RE: Palen Solar Power Project, Docket No. 09-AFC-7

Responses to January 14, 2010 CEC Workshop Queries – (Technical Area: Air Quality)

Request for Revised Construction Emissions Spreadsheet for the Palen Solar Power Project; and, Refinement to Palen Solar Power Project Air Permit Applications

Attachment 1
SCAQMD Correspondence Related to Six Data Adequacy Questions

FOR PERMITS

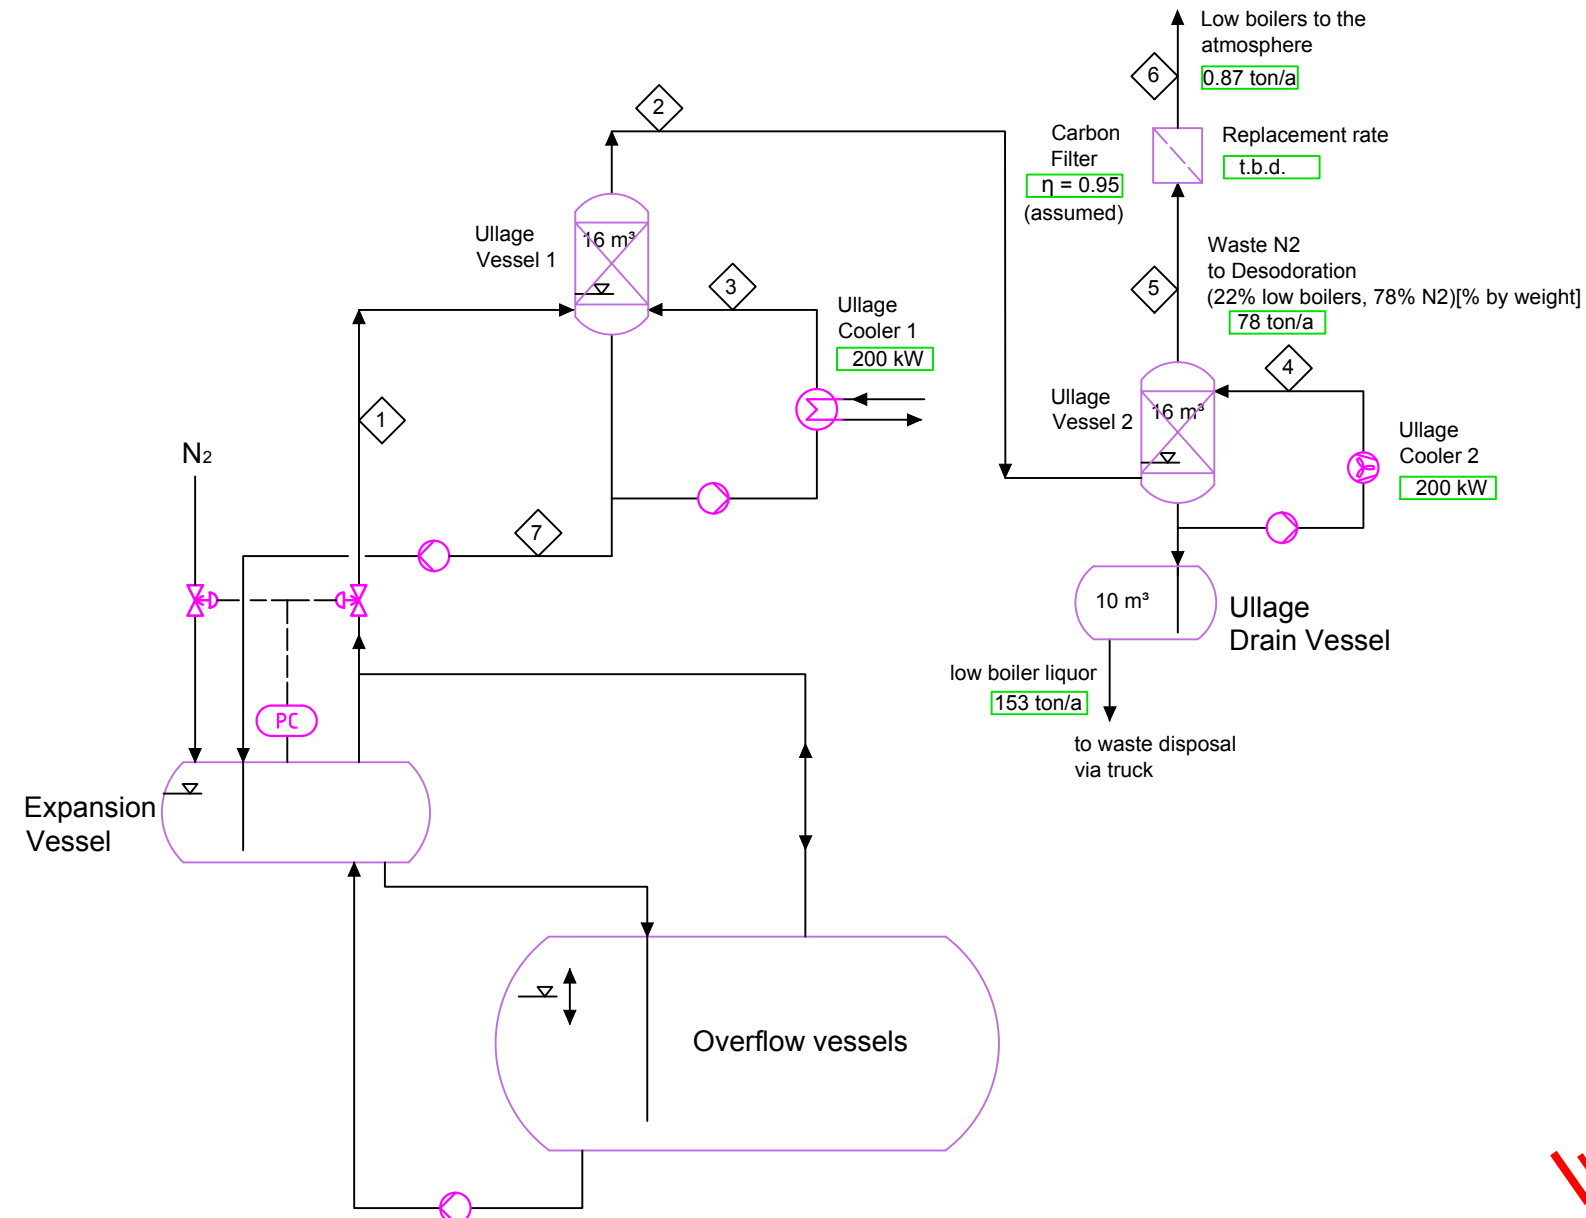
6. Regarding the proposed Ullage system and land treatment units, please provide a thorough description and quantities of the types of equipment each system will be comprised of, such as storage tanks, vessels, heat exchangers, and/or other such devices as applicable.

Response: The HTF (eutectic mixture of diphenyl oxide and diphenyl) degrades over time in low and high boiling products, which must be separated and eliminated from the cycle. Low boiling degradation products are a mixture of benzene, toluene, xylene and phenol; the concentration of each component of the mixture can differ considerably from plant to plant depending on many factors, and it can be difficult to determine day-to-day concentrations. A high concentration of low boilers in the HTF changes the fluid properties and increases risk of cavitation for the pumps. In order to limit this effect, a mixture of nitrogen, degradation gases and HTF vapor is vented from the expansion vessel and the overflow vessels. To maintain sufficient pressure within the HTF cycle, nitrogen is introduced in the expansion vessel.
